Docket Item #18
DEVELOPMENT SPECIAL USE PERMIT #2003-0017
CAMERON STATION PHASE VII

Planning Commission Meeting
November 6, 2003

ISSUE: Consideration of a request for a development special use permit, with site plan, for construction of a multi-family residential project.

LOCATION: 400 Cameron Station Boulevard

Phase VII site layout and open space plan

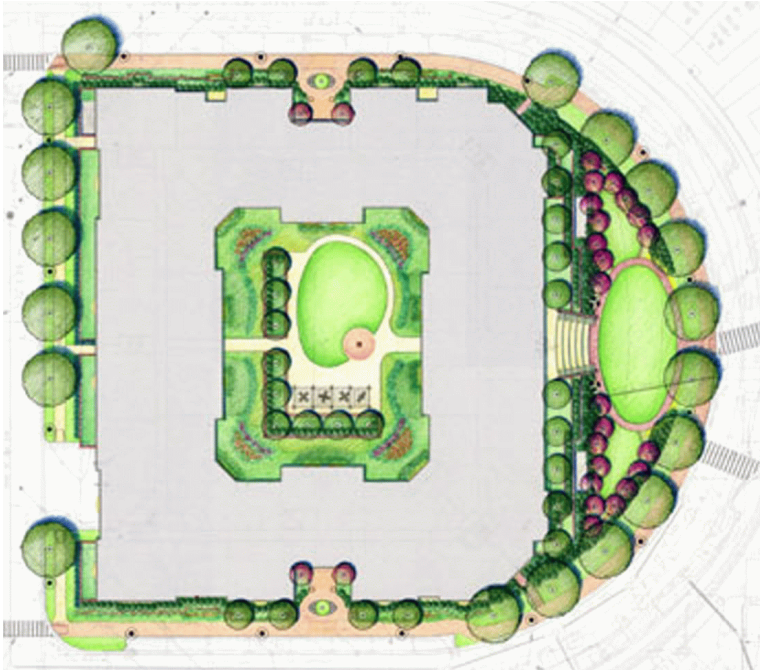
A large (12,000 sq. ft.) landscape area of visually accessible ground level open space is proposed on the eastern portion of the site. The center of the site contains an open space interior courtyard partially above-grade (on top of a level of parking), which will be approximately 15,000 sq. ft. This courtyard is to be treated with pavers, ground cover, landscaping, trees, and other amenities to provide useable private open space for the residents.

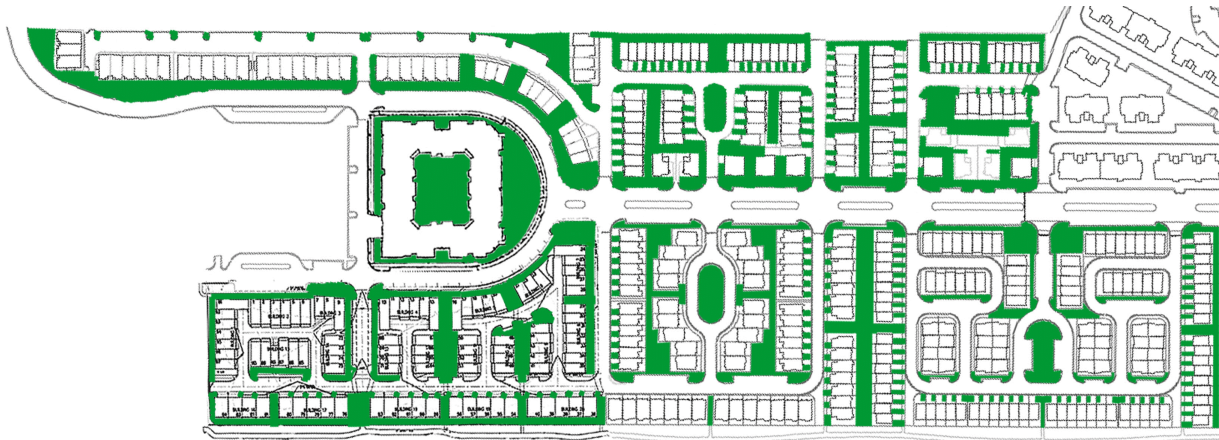
Staff recommended that the east facade be treated in an asymmetrical manner, using a pair of towers of different heights with the taller marking the axis of Cameron Station Boulevard. The applicant revised the plan to address this urban design issue. Another recommendation for the east facade is the elimination of one of the retaining walls at the base of the building and replace it with a landscaped berm, to reduce the apparent height of the building’s principal facade.

Finally, there are various recommendations made by staff to improve the scale and architectural quality of the project and its details which require additional refinement that include revising the arched passage on the east facade of the building to be treated as a full semicircle (instead of the segmental arch as shown), and the base story on the north and south elevations of the building should

be differentiated from the other parts by being clad in rusticated brick instead of precast. The rustication of the central portion of the building's east facade should be increased in height by a story to differentiate it from the corner massing elements.

Through the conceptual review process the applicant revised the overall design and roofline to provide the appearance of several smaller buildings which has been successful in reducing the perceived mass of the building.
